**RE: Lot 17 Block 6 Volcano Cliffs Unit 19 SAD 228
6309 Vista Del Prado NW
Grading and Drainage Plan
Engineers Stamp Date 3/29/2020 (D10D003F17)
Pad Certification Date 4/26/2020**

DRAINAGE AND TRANSPORTATION INFORMATION SHEET (REV 6/2018)

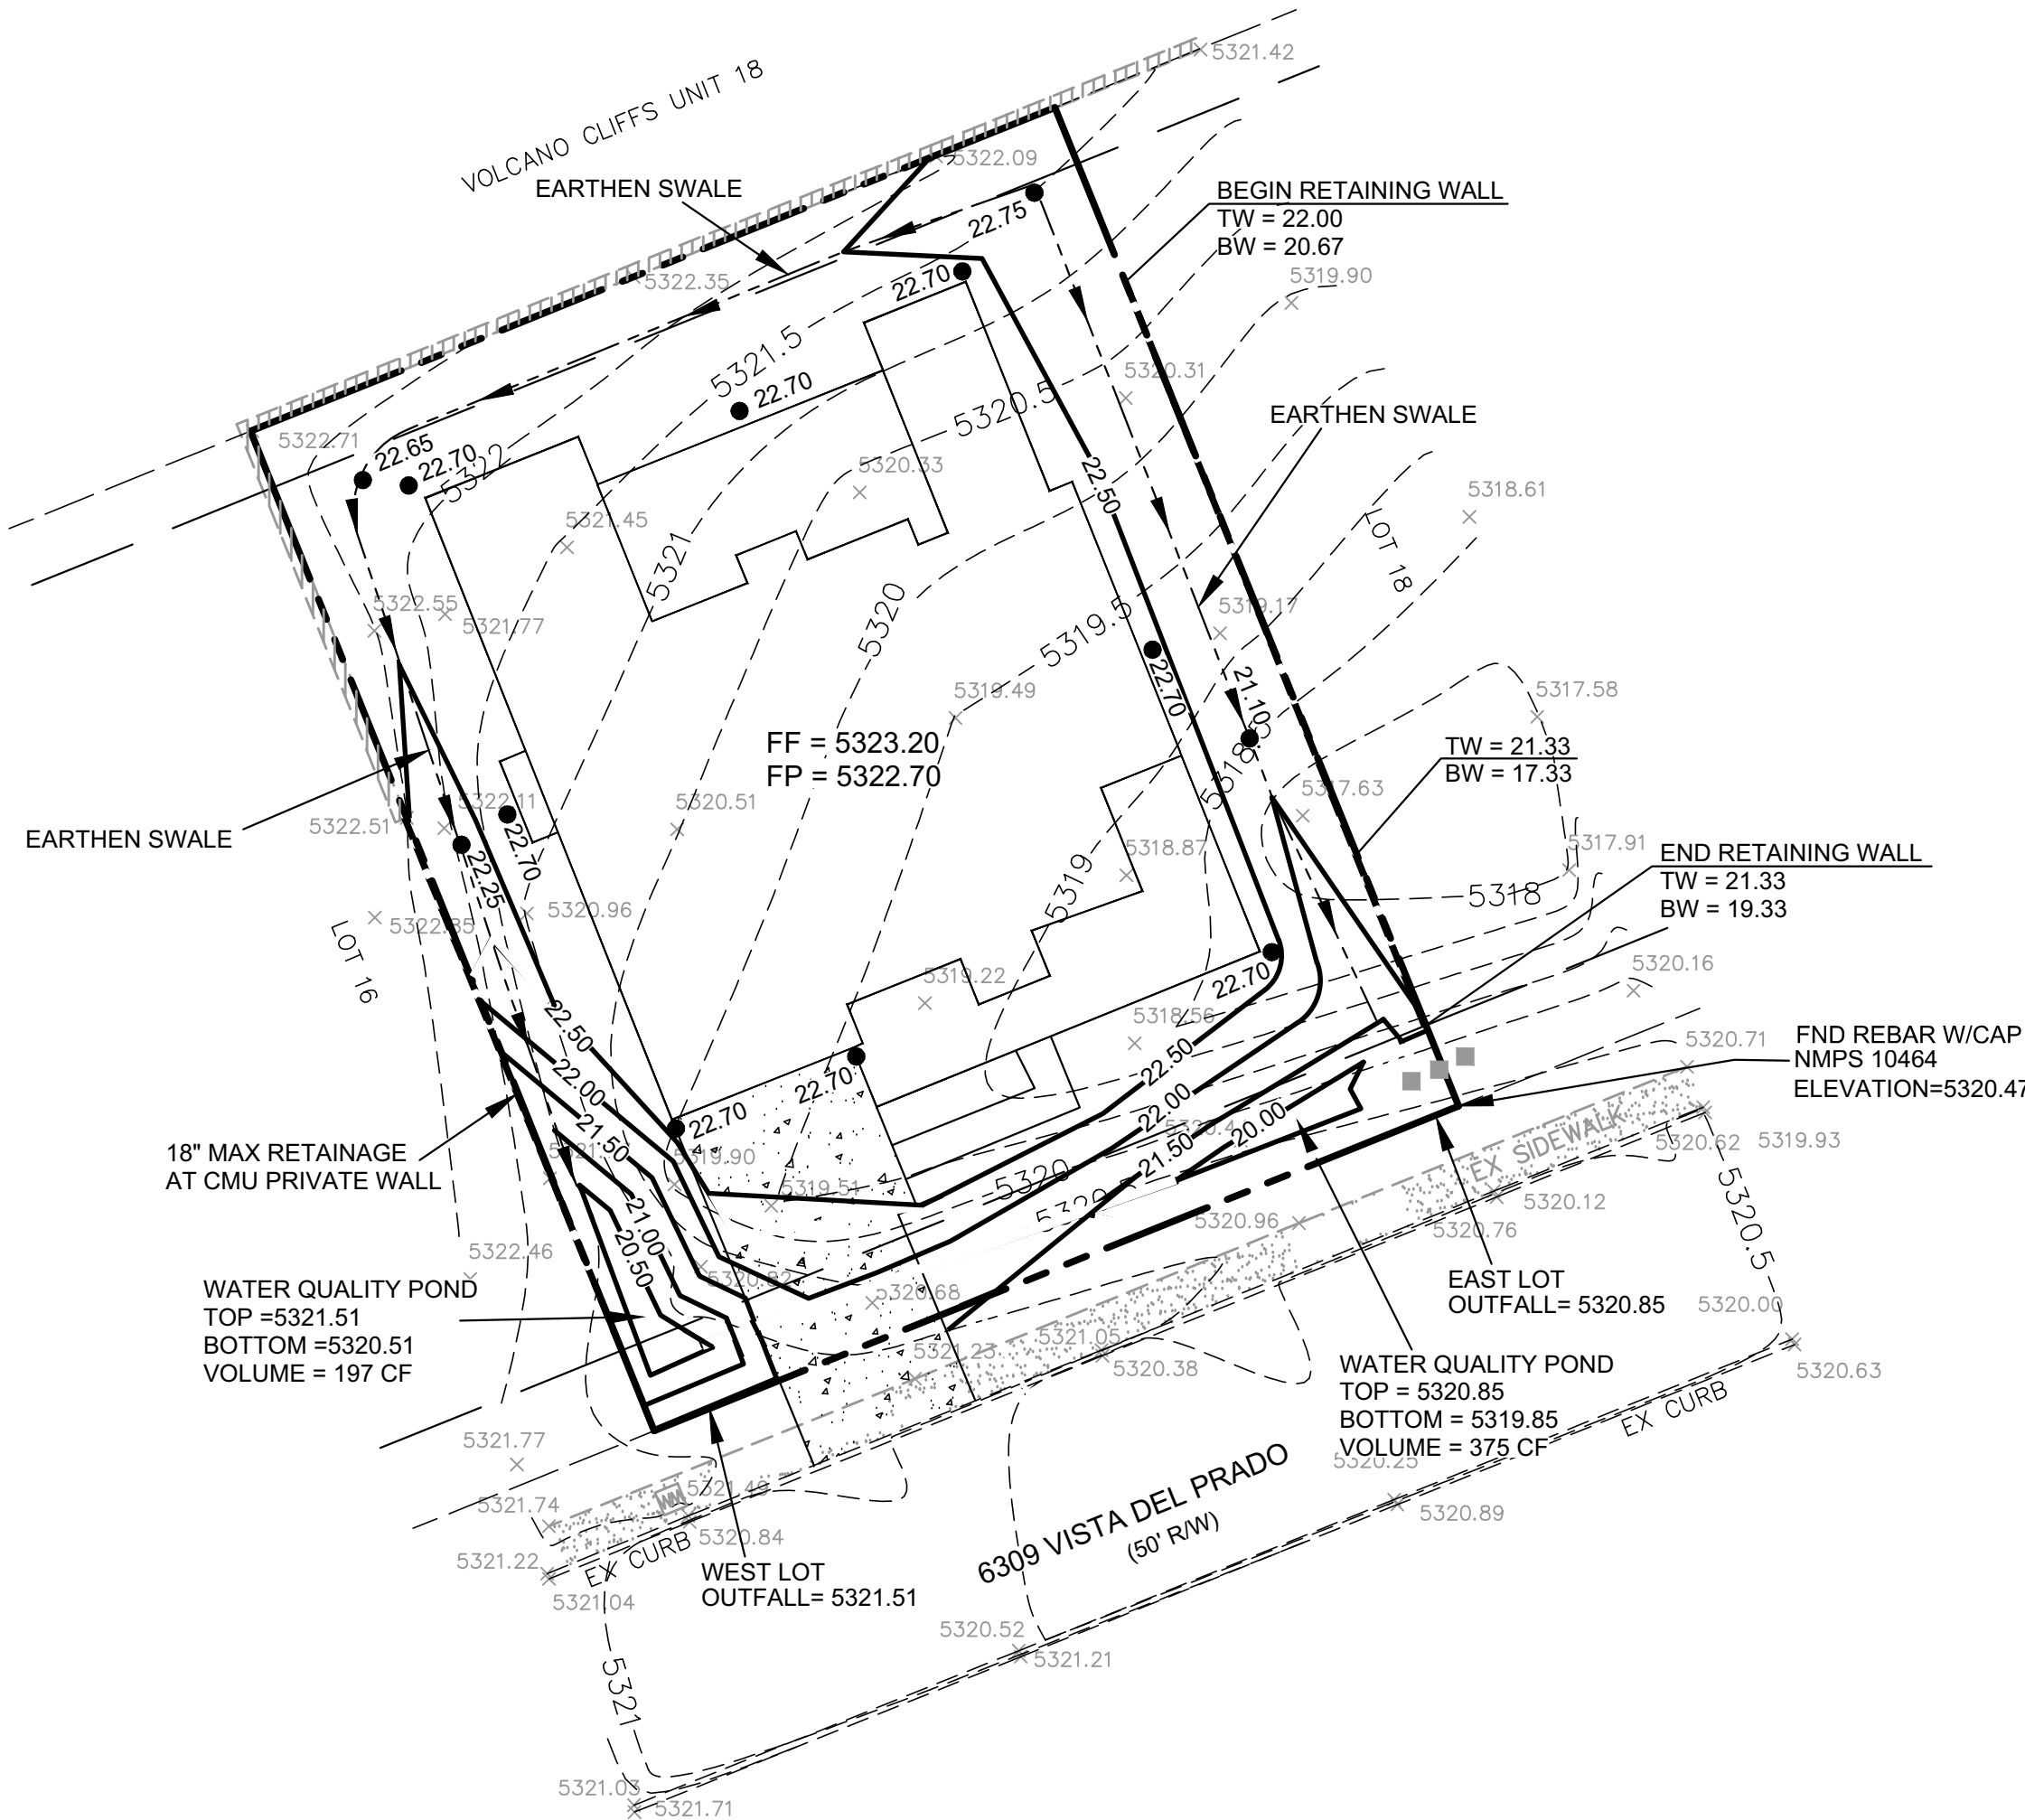
Based upon the information provided in your submittal received 4/28/2020, this plan is approved for Building Permit.

Reiterate to the Owner/Contractor that a separate permit for a garden/retaining wall must be obtained, with the approved G&D plan dated 3/29/2020 and Pad Certification Date 4/26/2020.

Prior to Certificate of Occupancy release, Engineer Certification per the DPM checklist of this plan will be required.
